Southern Water

Your Ref
FP/241/10/
Our Ref
S/AR/2010/241
Date
06/01/2011

Proposal: 1no. bungalow & associated parking & external works (re-submission following FP/155/09/)
Site: 21 Uppark Way, Felpham, Bognor Regis, West Sussex PO226QQ.
FP/241/10/

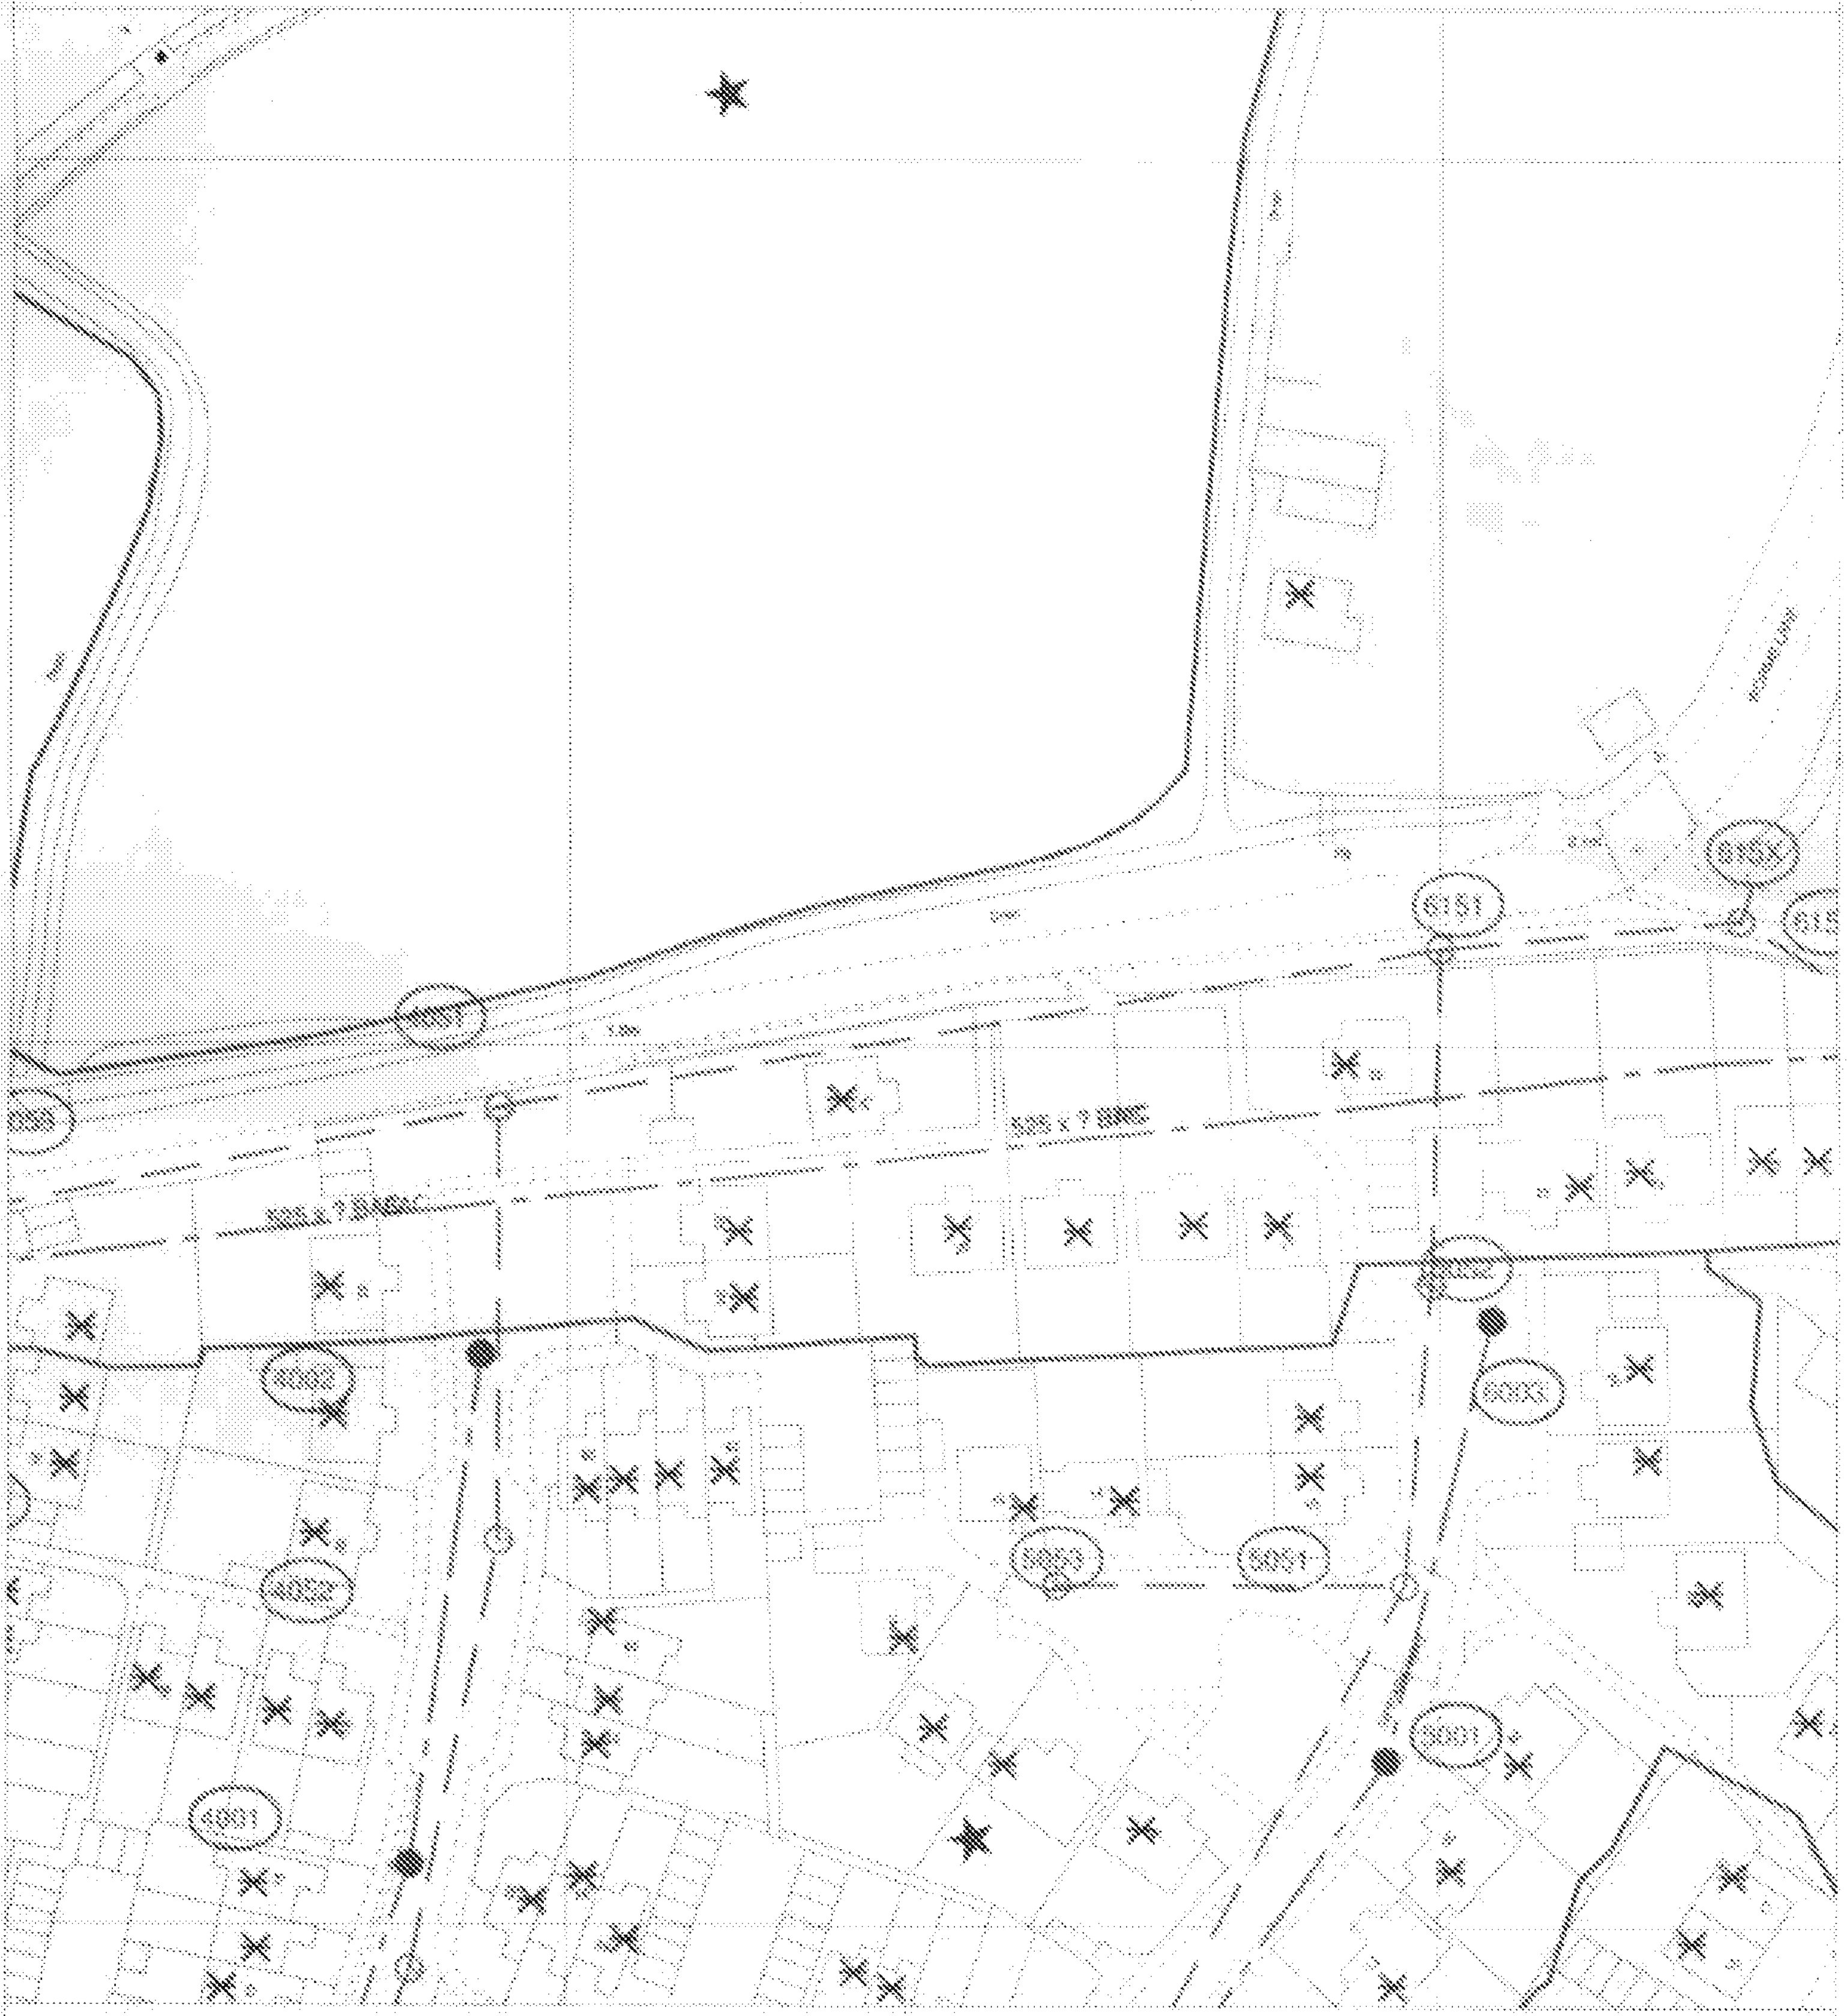
Please find attached a plan of the sewer records showing the approximate position of a public sewer crossing the site. The exact position of the public sewers must be determined on site by the applicant before the layout of the proposed development is finalised.

It might be possible to divert the public sewer, so long as this would result in no unacceptable loss of hydraulic capacity, and the work was carried out at the developer's expense to the satisfaction of Southern Water under the relevant statutory provisions.

1. The 525 mm diameter sewer requires a clearance of 3.5 metres either side of the sewer to protect it from construction works and allow for future access for maintenance.
2. No development or new tree planting should be located within 3 metres either side of the centreline of the public sewer
3. No new soakaways should be located within 5m of a public sewer.
4. All other existing infrastructure should be protected during the course of construction works.
